## I-45 North Houston Highway Improvement Project

# DESIGN SPECIFIC REQUESTS & RESPONSES BY NHHIP SEGMENT

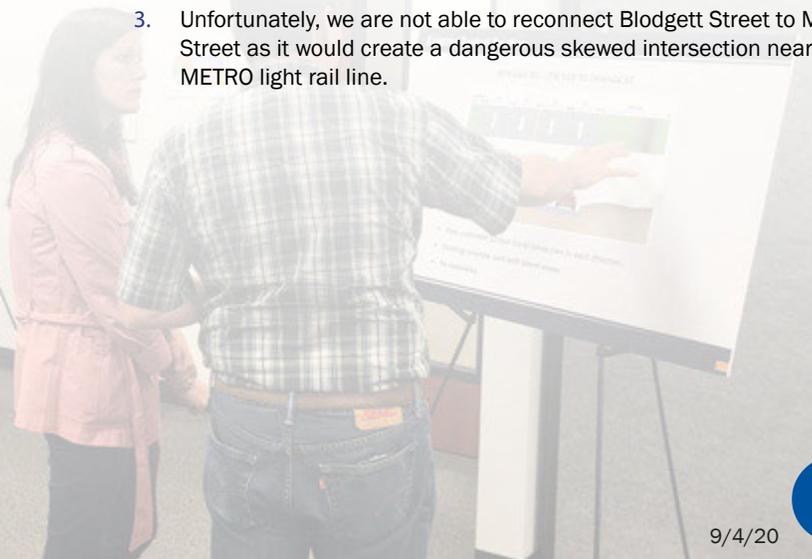
1. Add a Gregg Street eastbound exit ramp from I-10.
2. Close McKinney Street across the freeway (Councilmember Gallegos request).
3. Convert Walker Street into a pedestrian/bicycle only facility over freeway lanes (Councilmember Gallegos request).
4. Connect Cleburne Street across US 59/I-69.
5. Remove Montrose Bridge reconstruction from plan.
6. Remove impact to White Oak Park.

1. Adding this ramp appears to be feasible and will be further explored during the upcoming detailed design phase.
2. TxDOT has no objection to closing McKinney Street over the freeway, but the decision lies with the City of Houston. This can be decided after the ROD and incorporated during the detailed design phase.

3. TxDOT has no objection to converting Walker Street to a pedestrian/bicycle facility over the freeway, but the decision lies with the City of Houston. This can be decided after the ROD and incorporated during the detailed design phase.

4. We have completed a preliminary evaluation and re-establishing this connection appears to be feasible. We will study in more detail during the detailed design phase.

5. Montrose Bridge reconstruction removed from plan.
6. Revised design of the I-45 southbound to I-10 westbound direct connector to avoid the impact to Freed Art & Nature Park (noted in comments received as White Oak Park).

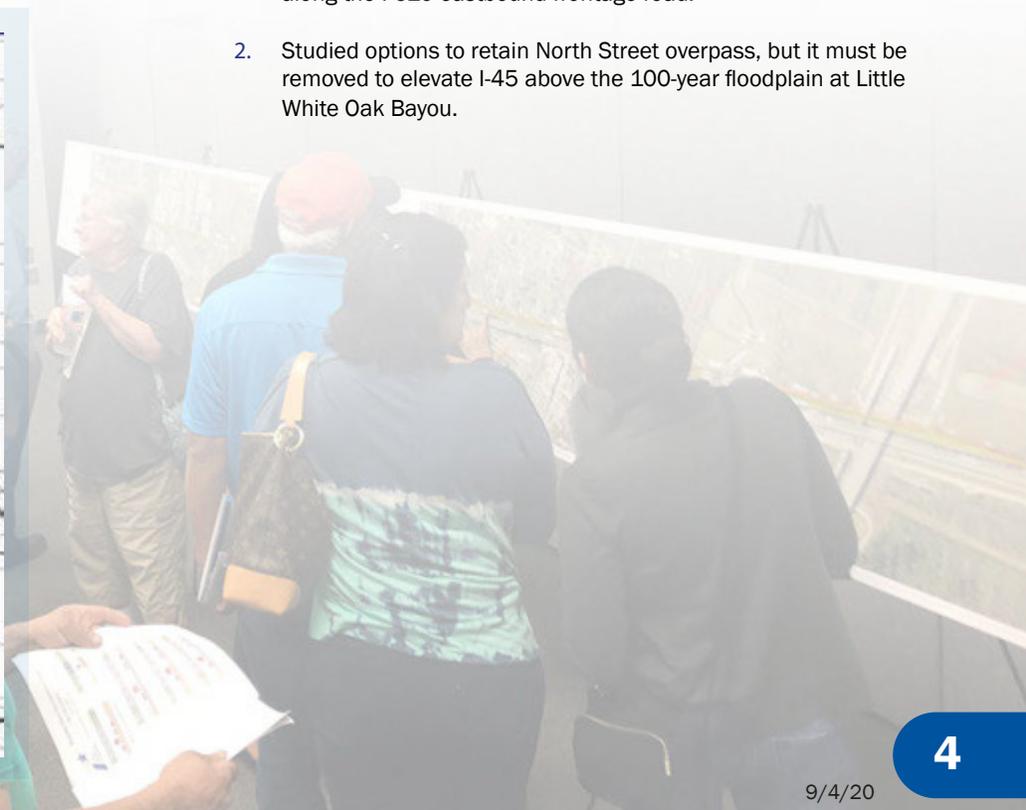
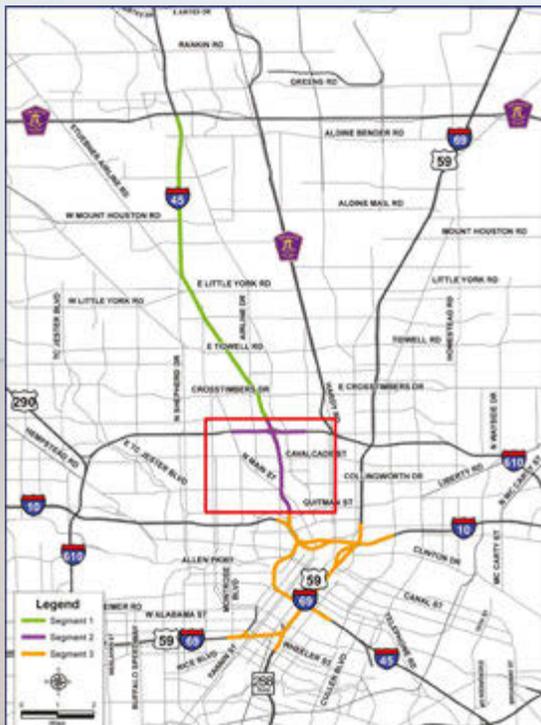
1. Replace Southbound exit ramp to North Main Street that was removed.
2. Provide access from North Street to the new northbound frontage road.

1. Existing southbound exit ramp to North Main Street could not be maintained without additional ROW and closure of Cottage Street to vehicular traffic across I-45. Preliminary design for a southbound exit ramp near Patton Street under review. Adding this ramp will be further explored during the detailed design phase.
2. Revised new I-45 NB frontage road to provide connection to North Street.

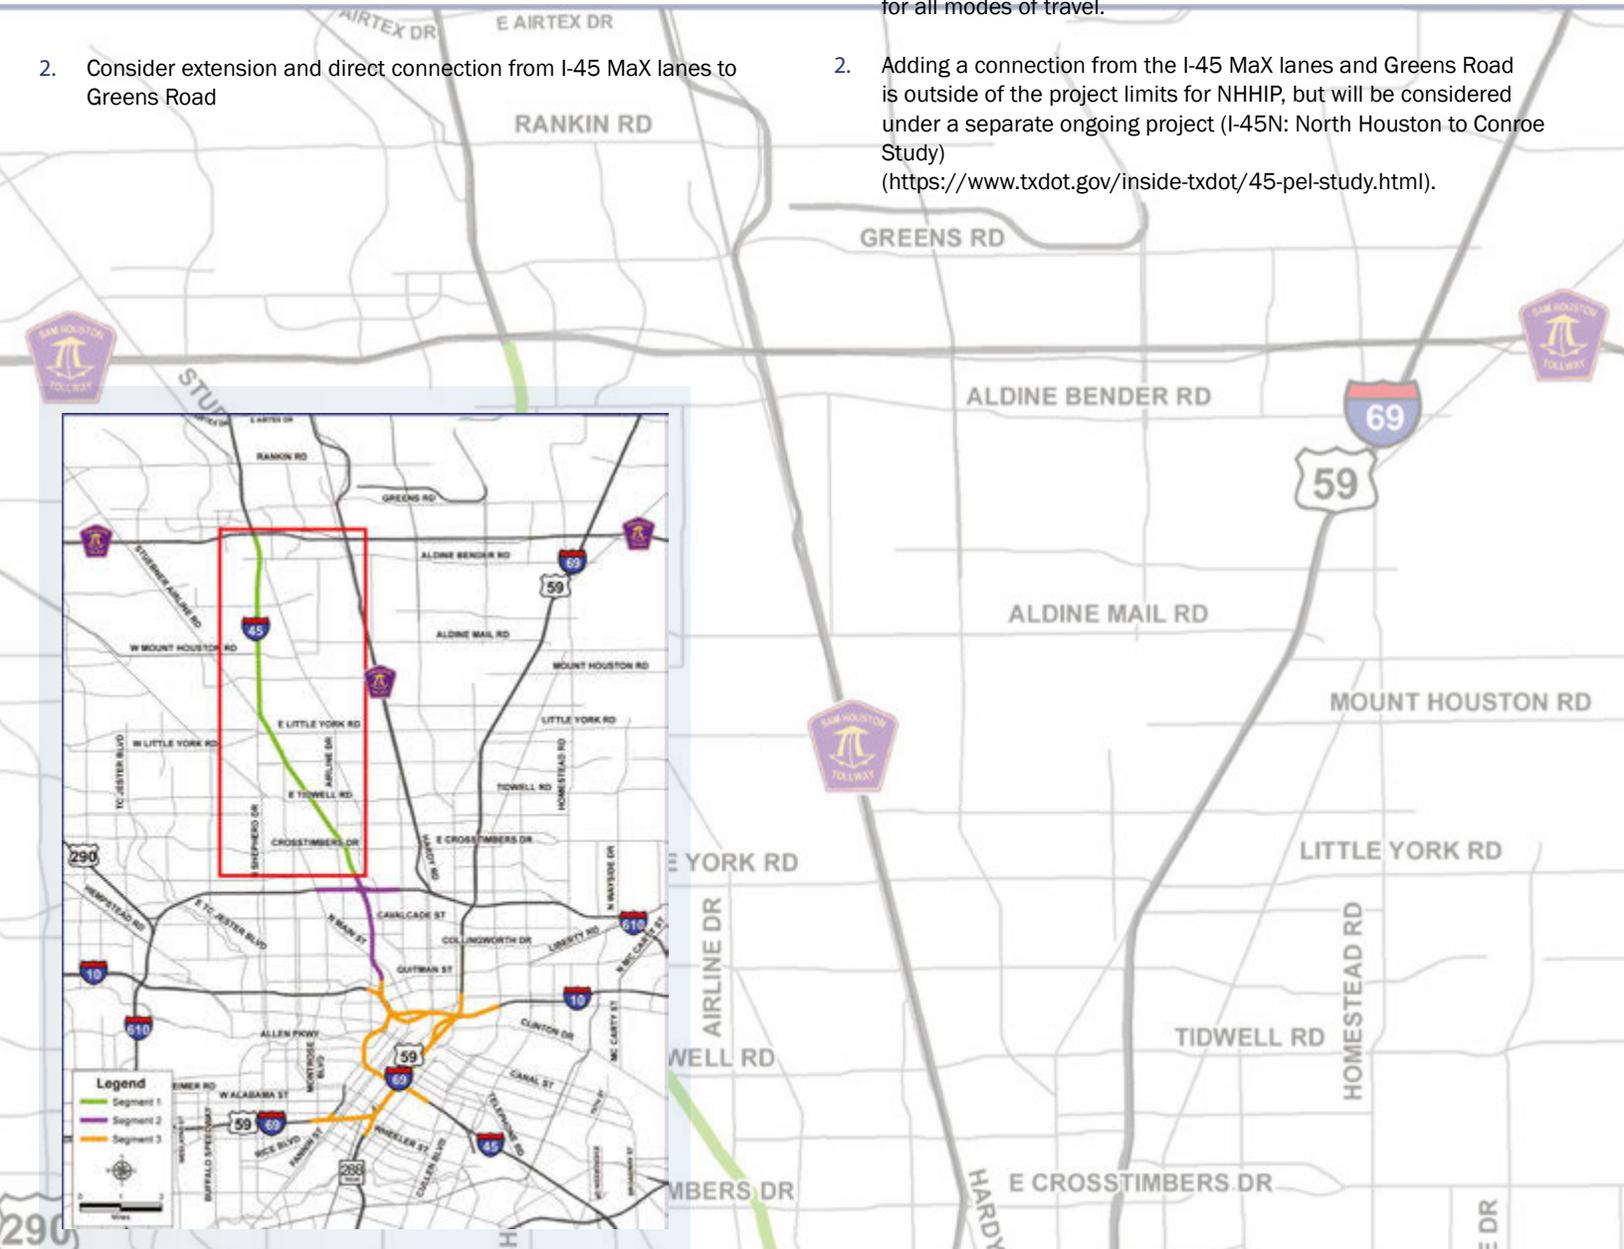
1. All intersections should be designed for safe crossings and accessibility for pedestrians especially with regard to METRO bus stops.
2. All lanes on city streets and frontage roads should comply with City of Houston's 11' lane standards. Multiple streets have been shown with sweeping, large radius turns; project should minimize these issues.
3. Define which intersections are proposed with traffic signals and all-way stop control.

1. TxDOT coordinated with the COH regarding the specific design of the city street network adjacent to and crossing the NHHIP. TxDOT also coordinated with the COH to incorporate the COH Bike Plan and desired bicycle/pedestrian accommodations on city streets. The intersection designs will be further refined during detailed design, in coordination with the COH and METRO.
2. Frontage road design will accommodate large radius turns and intersections will avoid pedestrian islands. The streets parallel to the freeway in Segments 2 and 3 will follow the City of Houston standards and lanes will be 11' wide. The frontage roads in Segment 1 function as a transition between the freeway and the local businesses and need to retain TxDOT design standards of 12' lanes.
3. Frontage road intersection signalization will be determined during the final design phase.
